**Re: #PLUS 2006-10-05; Lands of Givens (Shepherd Walk)
Tax Parcel No. 3-34-11.00-81.00**

RE: PLUS review – PLUS 2006-10-05; Lands of Givens

REVISED PRELIMINARY SUBDIVISION PLAN

SHEPHERD WALK

REVISED PRELIMINARY SUBDIVISION PLAN
 FOR PROPERTY KNOWN AS:
SHEPHERD WALK
 ALSO KNOWN AS:
LANDS OF RUSSELL L. & DOROTHY I. GIVENS
 PREPARED FOR:
CORNERSTONE DEVELOPERS
 SITUATE IN:
LEWES & REHOBOTH HUNDRED * SUSSEX COUNTY
STATE OF DELAWARE
 TAX PARCEL #: 3-34-11.00-81.00
 SCALE: 1" = 100'

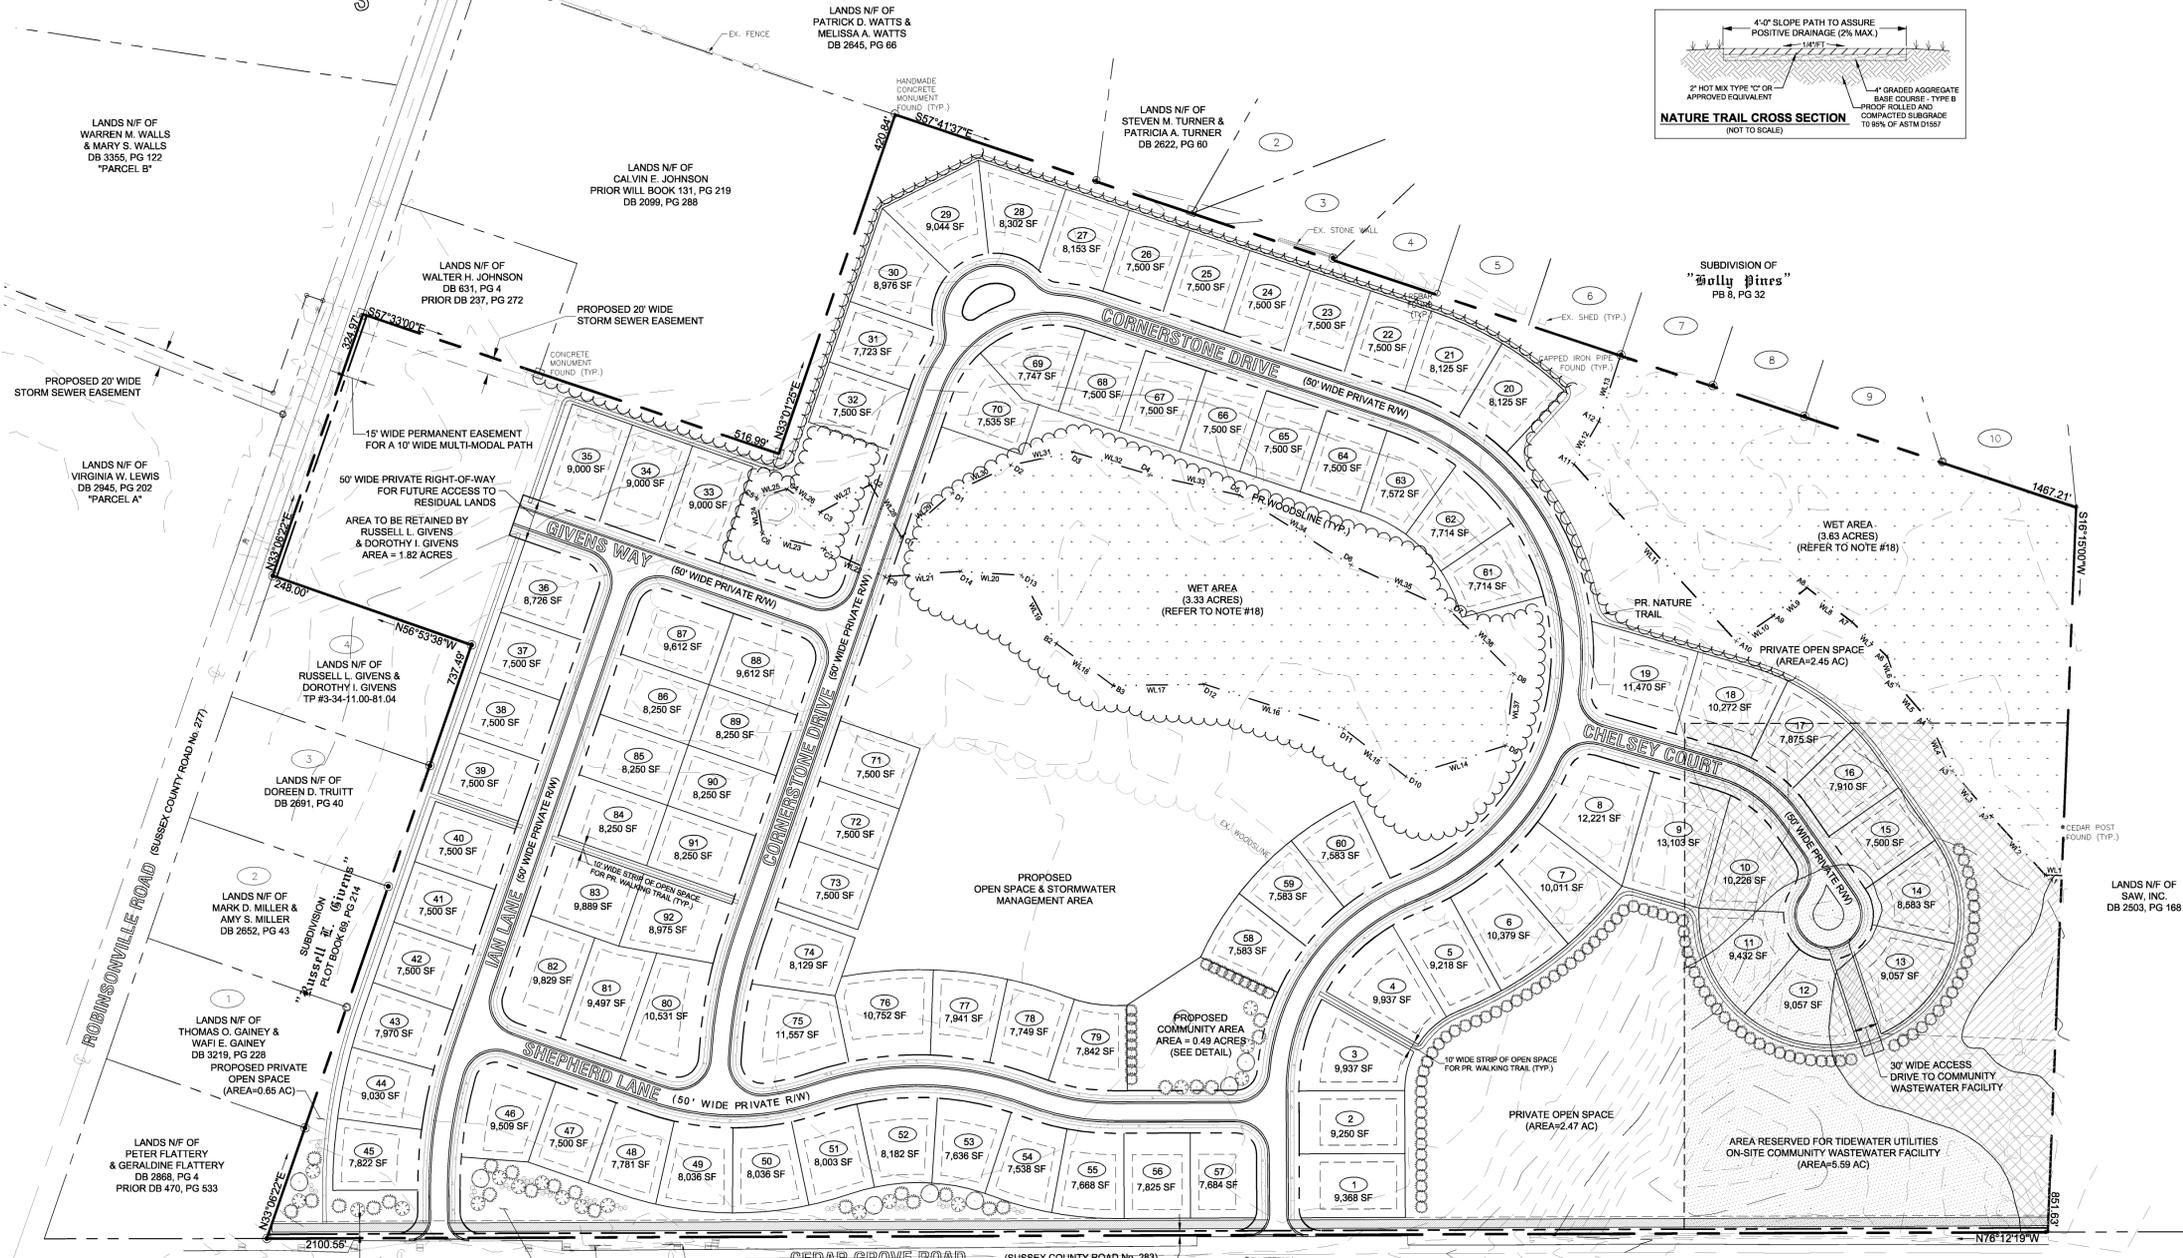
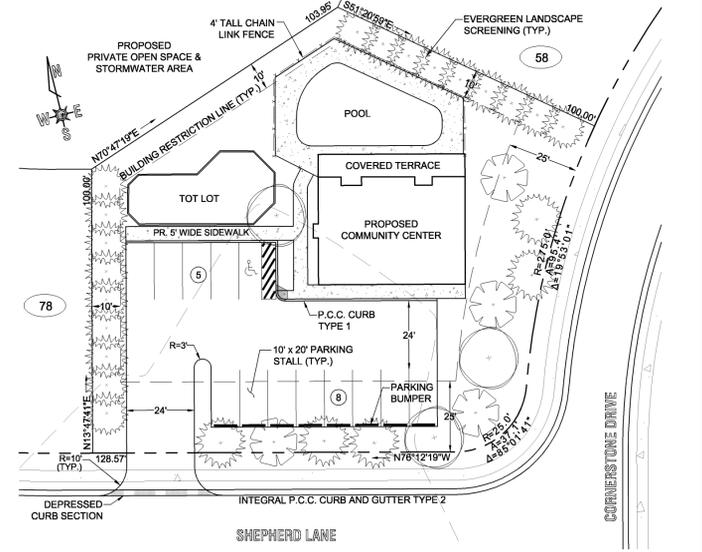
- The creation of an outlot to be retained by Mr. & Mrs. Givens is acceptable, but that lot must be accessed through the proposed development streets rather than directly from Robinsonville Road. *{The revised plan has provided for a stub street connection to the outlot that will be retained by the Givens providing access from an interior subdivision street.}*

- The amount of forest loss estimated by the applicant should be re-evaluated, as the applicant states 12.7 out of 21.68 acres will be cleared. However, there are at least 42 completely forested lots, 18 partially wooded lots and roadways within the forested area. Not only will these lots be cleared for homes, driveways and garages but subsequently by homeowners for sheds, play areas, pools, kennels etc. Although stated on the site plan, there does not appear to be 18 acres of forest preserved and what is maintained will be fragmented by lots and infrastructure. *{The plan now under consideration has been substantially revised from the plan that was reviewed by PLUS. Most significantly the number of lots has been reduced from 115 to 92. The updated forest loss estimates are as follows:}*

- 5) The creation of an outlot to be retained by Mr. & Mrs. Givens is acceptable, but that lot must be accessed through the proposed development streets rather than directly from Robinsonville Road. DeIDOT would prefer that a second access to the development be built on Robinsonville Road (which would provide additional entry for emergency services) and if that were done Mr. & Mrs. Givens' outlot could be accessed from that street. Alternatively, a driveway easement could be provided in the area of Lots 35 through 38 to serve the outlot. *{The revised plan has provided for a stub street connection to the outlot that will be retained by the Givens providing access from an interior subdivision street through the subdivision. A second access has been provided to Cedar Grove Road providing an additional entry point for emergency vehicles.}*

The amount of forest loss estimated by the applicant should be re-evaluated, as the applicant states 12.7 out of 21.68 acres will be cleared. However, there are at least 42 completely forested lots, 18 partially wooded lots and roadways within the forested area. Not only will these lots be cleared for homes, driveways and garages but subsequently by homeowners for sheds, play areas, pools, kennels etc. Although stated on the site plan, there does not appear to be 18 acres of forest preserved and what is maintained will be fragmented by lots and infrastructure.

- Any dead end road more than 300 feet in length shall be provided with a turn-around or cul-de-sac arranged such that fire apparatus will be able to turn around by making not more than one backing maneuver. The minimum paved radius of the cul-de-sac shall be 38 feet. The dimensions of the cul-de-sac or turn-around shall be shown on the final plans. Also, please be advised that parking is prohibited in the cul-de-sac or turn around. *{There is one (1) proposed cul-de-sac street which will have a minimum paved radius of 38 feet.}*

PURPOSE NOTE:
THE PURPOSE OF THIS PLAN IS TO REVISE THE PRELIMINARY SUBDIVISION PLAN FOR SHEPHERD WALK AS SUBMITTED TO SUSSEX COUNTY PLANNING & ZONING ON JANUARY 29, 2007. BY THE FOLLOWING CHANGES:
1) THE NUMBER OF LOTS HAS BEEN REDUCED FROM 112 TO 91.
2) A DENSITY BONUS PURSUANT TO SECTION 115-25B (3) OF THE SUSSEX COUNTY CODE IS NO LONGER BEING SOUGHT.
3) THE AMOUNT OF OPEN SPACE HAS BEEN INCREASED FROM 19.72 ACRES (40.5%) TO 23.20 ACRES (48.8%).
